Aldington & Mersham Support Group Comments on the Applicants Responses to Relevant Representations (REP1-061)

The Applicant has responded to our **Relevant Representation (RR-003)**. The following document details our comments to this response in the order in which they were responded to by the Applicant. The relevant sections from the Applicant's response are shown in italics with our comments below. We have also made comments regarding the Draft **DCO (APP-015)** and the **Funding Statement (REP1-012)**.

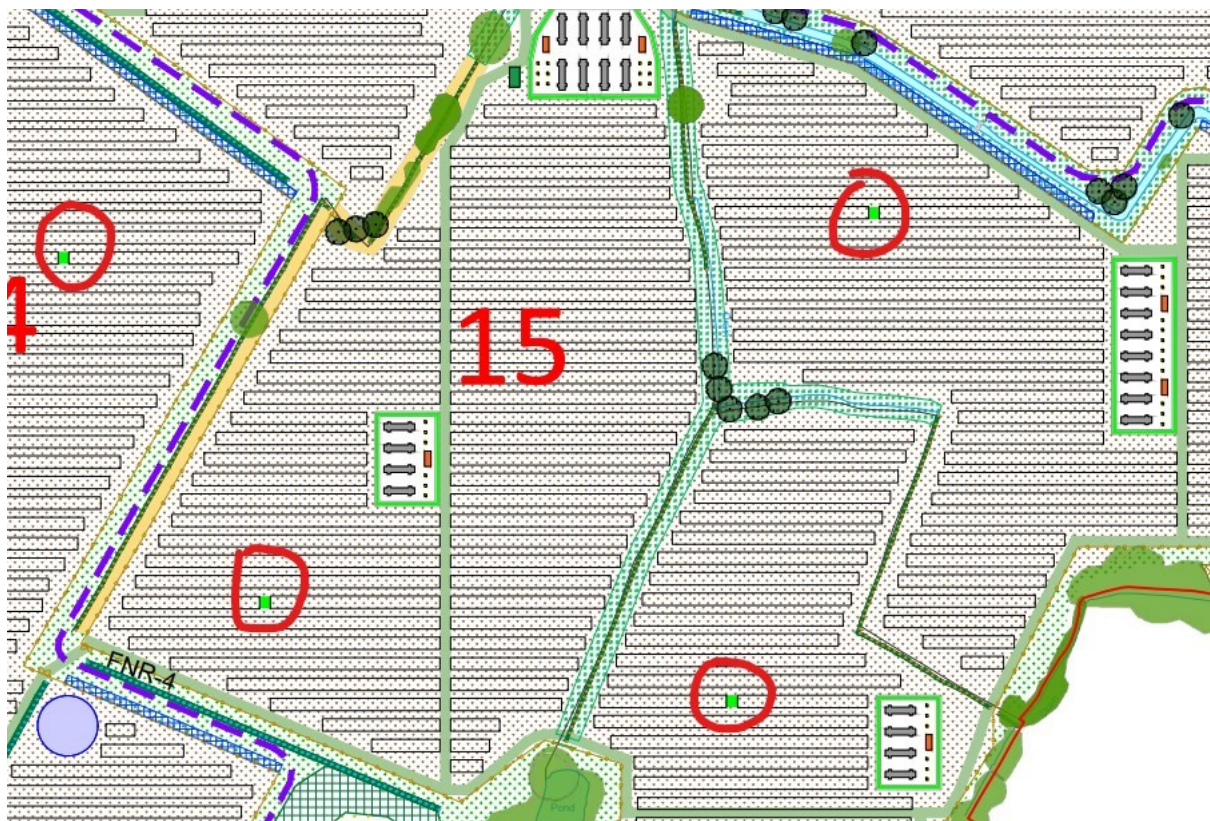
The true position is that mammal movements **will be restricted** because the only means of them accessing existing foraging areas will be through an unspecified number of mammal gates. Why has the Applicant not indicated a minimum number of these gates to be installed?

The Applicant refers to the **Outline Landscape and Ecological Management Plan Doc ref 7.10 and** at 5.2.2 confirms that *“The Project boundary fences will **look to** include ground level gaps*

and/or mammal gates to allow movement of species, such as brown hare and badger”. (Bold font our emphasis).

Why has the Applicant not said, “will include” rather than that it will “look to include”?

Beckett's Green: The applicant's proposed layout of BESS and panel footprint

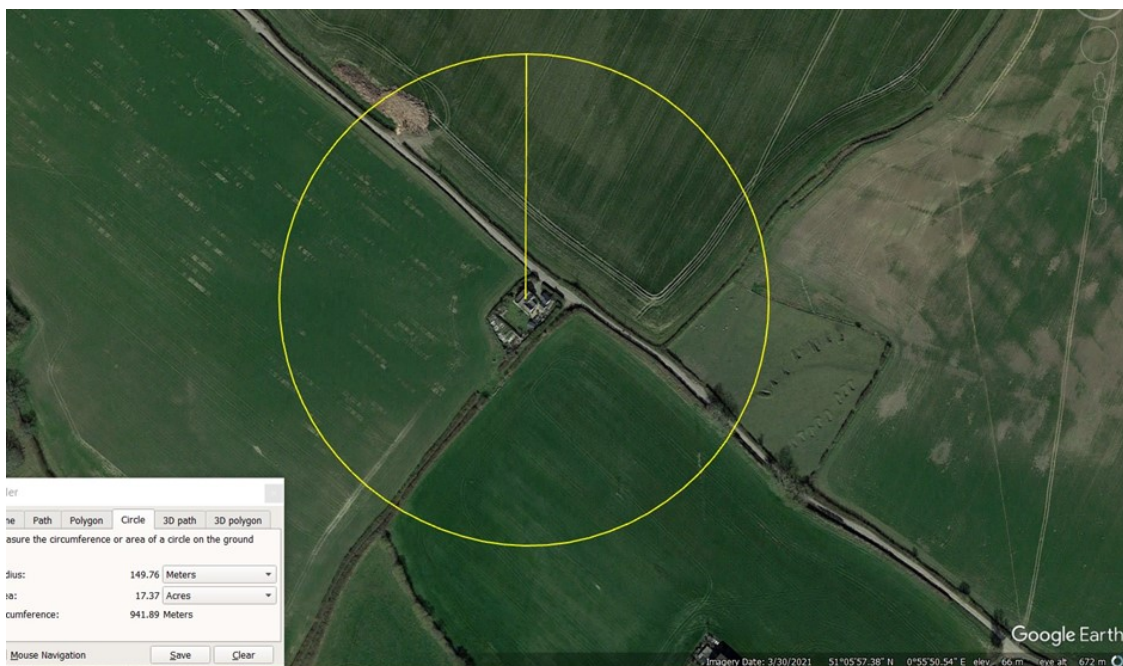
The plan below shows the meagre changes offered by way of reduced footprint (shaded orange to the northwest of her house).

Why can't the applicant offer the same safeguarded area to Mrs Chafer as EDF have offered to homeowners and if not, why won't they *volunteer* to compensate her for her loss?

The Applicant all too quickly relinquished fields 26 – 29 apparently without any material impact on the scheme’s viability. Why can it not be more generous to Mrs Chafer while at the same time reducing visual impact on this highest part of the scheme? All the land within the circle is above the 58m contour – the area of the scheme with the greatest visual impact.
